# Access Compliance Report Public Rights-of-Way (Curb Ramps)

Main Street: FAIRHAVEN\_AVE Cross Street: S\_WINTHROPE\_ST Location: NW

ADA ID: RPRK211006174917 Ramp Type: Type 1 - Perpendicular Diagonal Initial Pass/Fail: Fail Overall Compliance: No Severity Score: 2

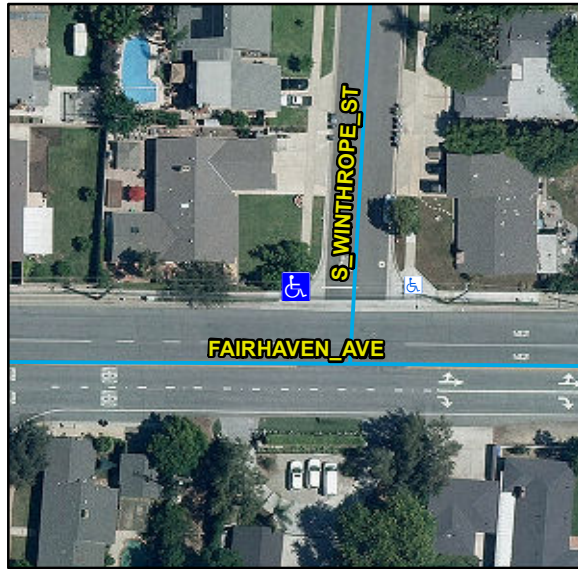
| Compliance | Description                           | Data | Compliance | Description                   | Data |
|------------|---------------------------------------|------|------------|-------------------------------|------|
| No         | Ramp Cross Slope (%)                  | 4.5  | N/A        | Flare Traversable LT          | N/A  |

Remove & Replace Curb Ramp With Two New Directional Ramps or Equivalent.

R304.2.2, R304.5.3, STD 1115
